RE: **DOCKET NO. 508** – The United Illuminating Company (UI) Certificate of Environmental Compatibility and Public Need for the Milvon to West River Railroad Transmission Line 115-kV Rebuild Project that consists of the relocation and rebuild of its existing 115- kilovolt (kV) electric transmission lines from the railroad catenary structures to new steel monopole structures and related modifications to facilitate interconnection of the rebuilt 115-kV electric transmission lines at UI's existing Milvon, Woodmont, Allings Crossing, Elmwest and West River substations along approximately 9.5 miles of the Connecticut Department of Transportation's Metro-North Railroad corridor traversing the municipalities of Milford, Orange, West Haven and New Haven, Connecticut. **Partial Development and Management (D&M) Plans – Segments 2, 3 and 4 Revisions.**

Re: Docket No. 508 - The United Illuminating Company Application for a Certificate of Environmental Compatibility and Public Need for the Milvon to West River Railroad Transmission Line 115-kV Rebuild Project – Request for Modification to Segments 2-4 Development and Management Plans

UI has updated several drawings. These updates include mod

Westwood TYPICAL PERMANENT ACCESS ROAD TO REMAIN SECTION RD02 NOT TO SCALE

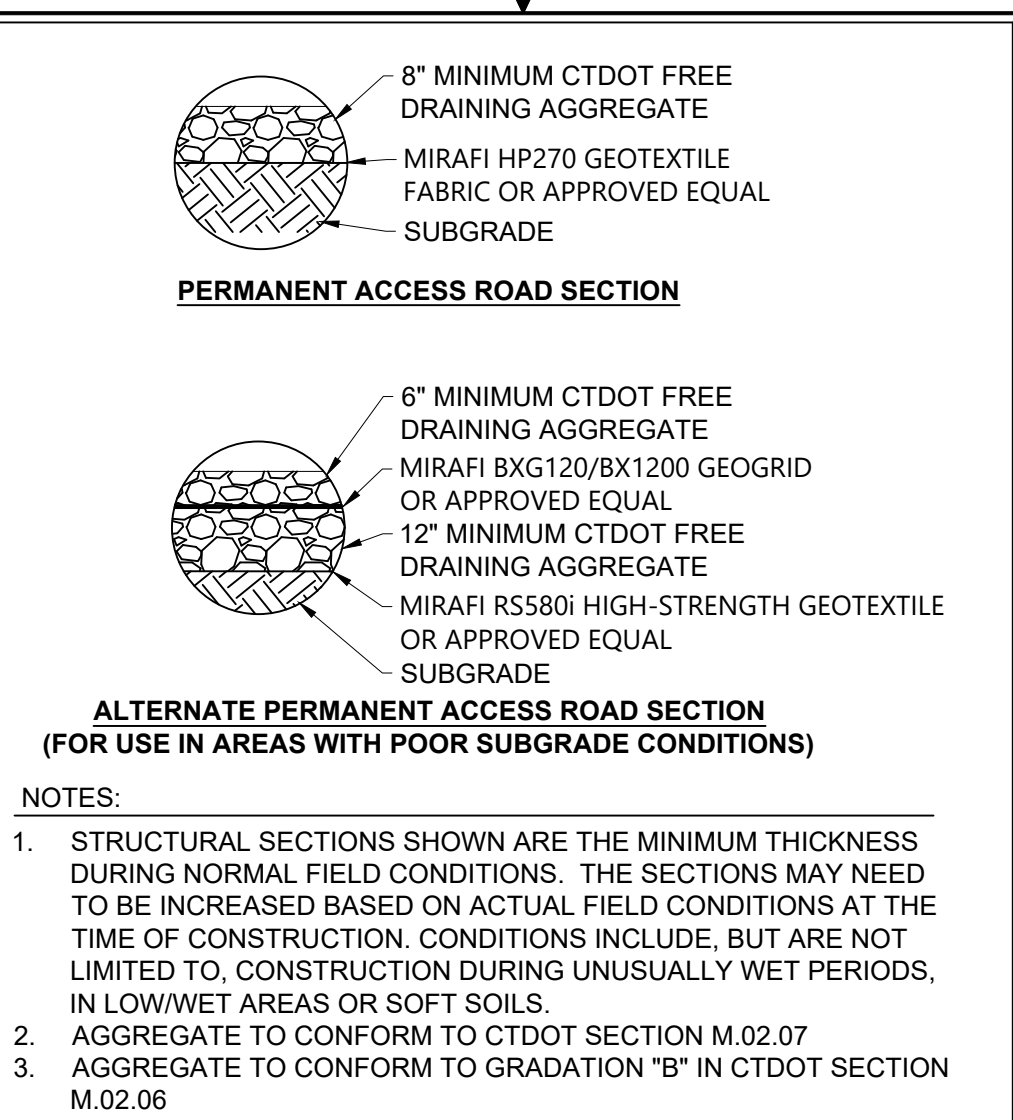
- a) Update access road notes on RD02;
- b) Update erosion and sedimentation control notes on ESC01, GD43, and GD45
- c) Include DN54 temporary mat bridge stream crossing design and notes; and
- d) Include additional mat bridge drainage crossings of O-WC1, O-WC2 and WH-WC4 per Drainage Crossing Schedule, DC13 and DC15.
